THE NATIONAL BOARD  
OF BOILER AND PRESSURE VESSEL INSPECTORS

# NATIONAL BOARD INSPECTION CODE COMMITTEE

## MAIN SESSION MINUTES

Meeting of January 12<sup>th</sup>, 2023  
Charleston, SC

Figure S2.13.4.1

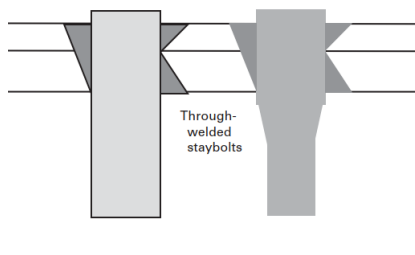
After beveling, and prior to the installation of the stay, the two plates, ~~should be~~ welded, should be ~~and~~ ground back to match the bevel prep. To facilitate installation, heating the through stay will aid in tensioning the stay and prevent sag. Excessive preload applied to the stay ~~should~~ shall be taken into consideration.
